# RECORD OF DECISION

**BALDWIN PARK OPERABLE UNIT  
SAN GABRIEL VALLEY SUPERFUND SITES  
LOS ANGELES COUNTY, CALIFORNIA**

**United States Environmental Protection Agency  
Region 9 - San Francisco, California**

Part III. Responsiveness Summary

BALDWIN PARK OPERABLE UNIT RECORD OF DECISION  
Figure RS-2

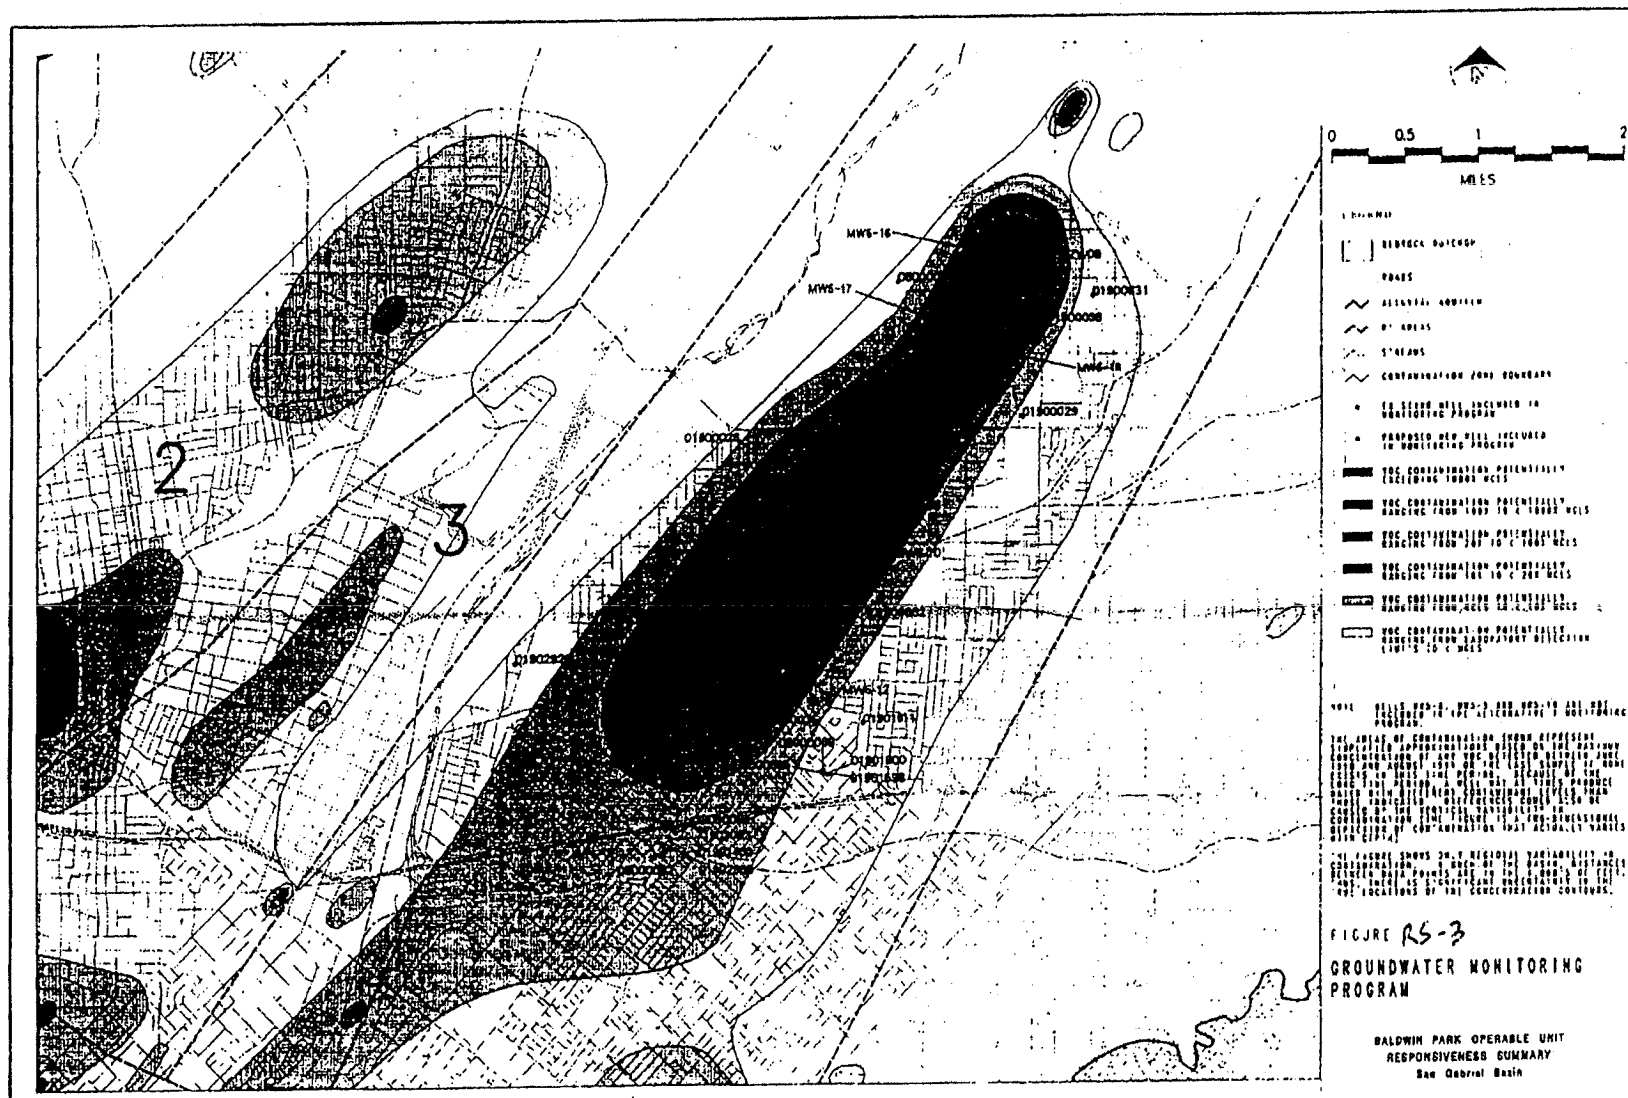
EPA Response: This comment largely duplicates other comments. See response to comments Aj#2 on the preparation and proper use of Figure 3-1.

We have prepared a revised figure (included as Figure RS-2) that includes well recordation numbers.

FIGURE RS-5  
SIMULATED CONTOURS  
OF GROUNDWATER ELEVATION  
32,500 GPM SCENARIO

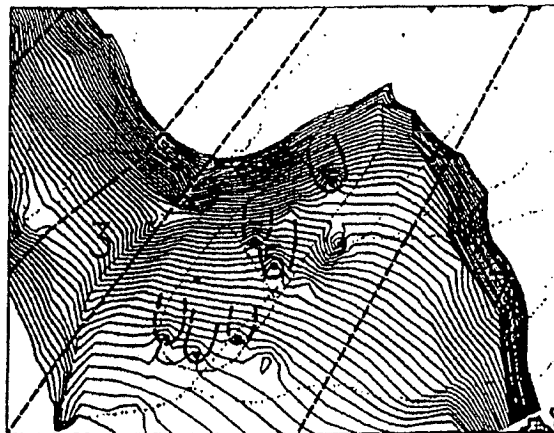
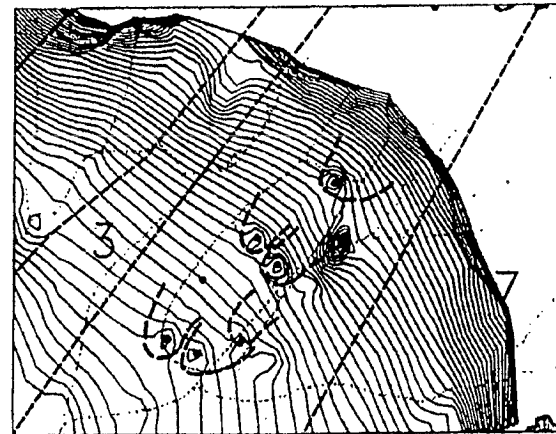
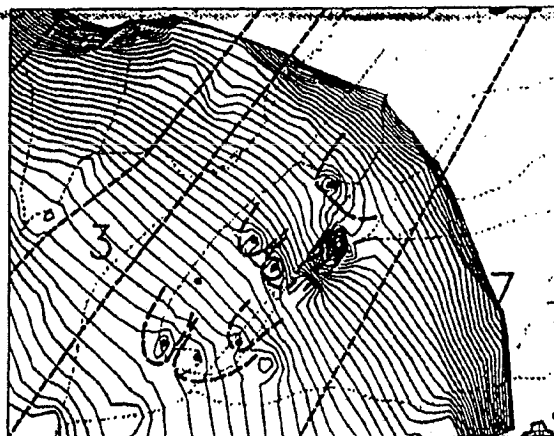
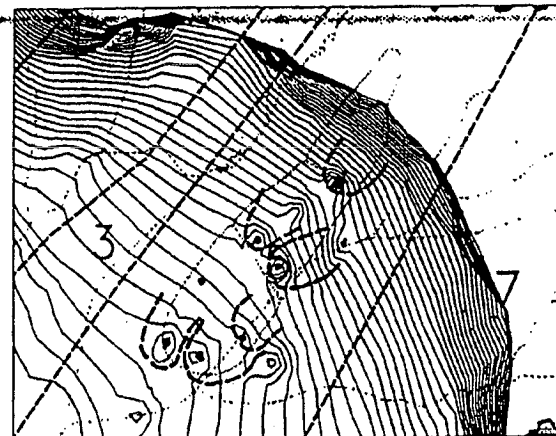
Aj#156. "It is unclear why Figure 7-8 presents the optimum well arrangement and rate for the OU. No selection criteria were established prior to discussion of simulation results, no capture zones are shown on the figure, the Subarea boundaries are not concentration related, and how each simulation arrangements achieves selection criteria is not discussed. To independently validate the selection of well locations and pumping rates, a significantly more detailed discussion on the modeling and selection procedure is needed."

EPA Response: We have added capture zones to Figures 7-5 through 7-8. They are included in this Responsiveness Summary as Figures RS-4 through RS-7. We have also added capture zones to Figure 12-2; the revised Figure is included as Figure RS-8.

Capture zones were not drawn on the referenced figure (or the rest of these groundwater contour figures) so that the reader can have an unobscured picture of the simulated groundwater contours resulting from the extraction scenario. As stated on page 7-12 of the FS, the zone of influence for each extraction well can be added to the figure for each quarter "by drawing lines perpendicular to the contours and noting whether they terminate at one of the potential extraction locations." However, revised figures are attached (Figure RS-4 to 8) that include approximate capture zones.

BALDWIN PARK OPERABLE UNIT RESPONSIVENESS SUMMARY  
Figure RS-11

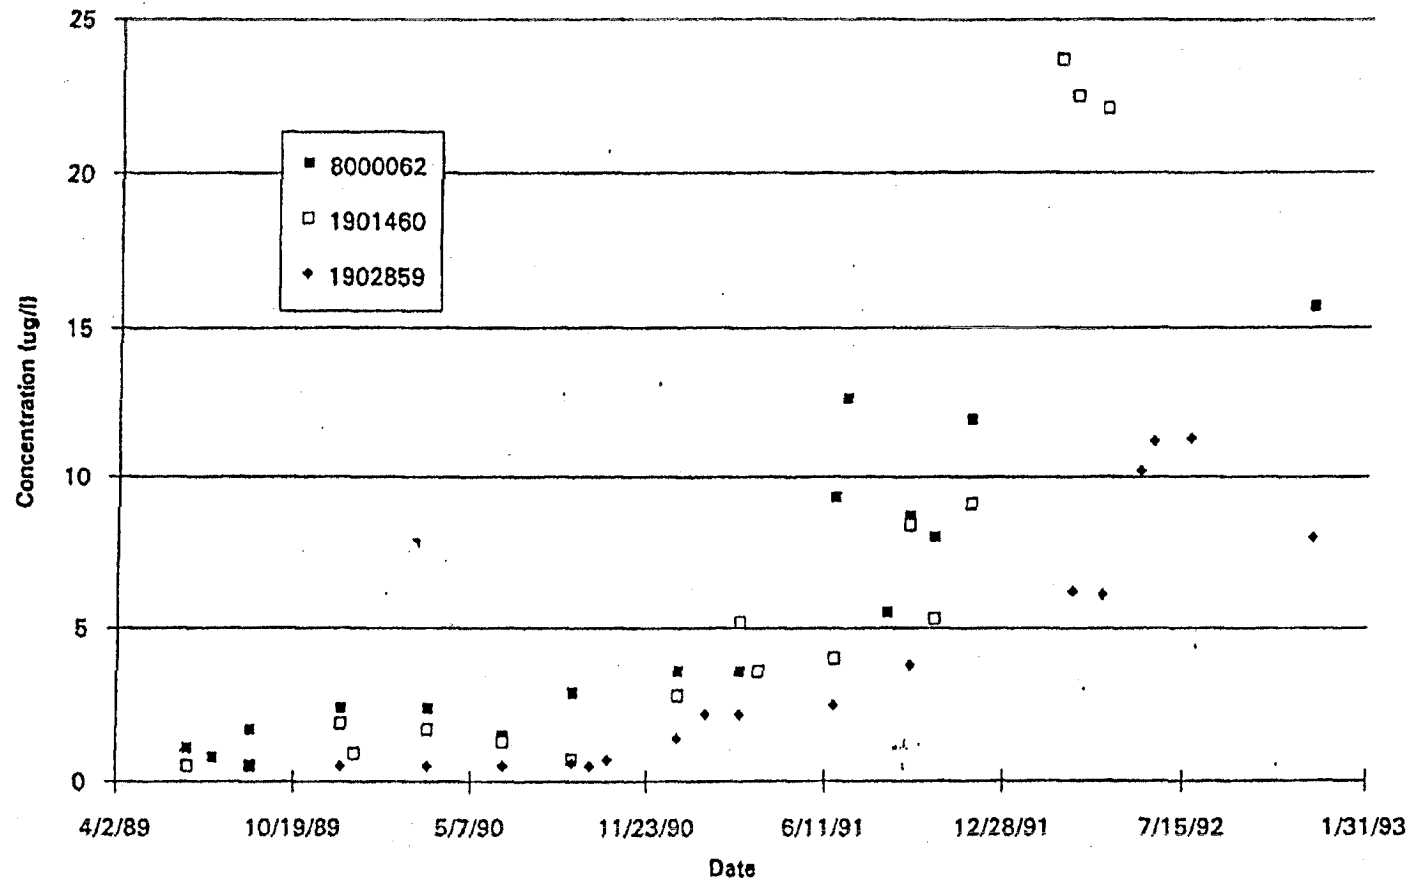
Contaminant concentrations are not, as asserted by the Coalition, uniformly stagnant or declining in and downgradient of Subarea 3. As described in part A.1 of this response (and shown in Figures RS-9 to 11), concentrations of the primary contaminants TCE and CTC have increased at 6 of the 10 wells in the area over the last 4 years. This indicates that contamination is continuing to migrate within and downgradient of Subarea 3. Three other wells show decreasing trends of the primary contaminant (either TCE or CTC).
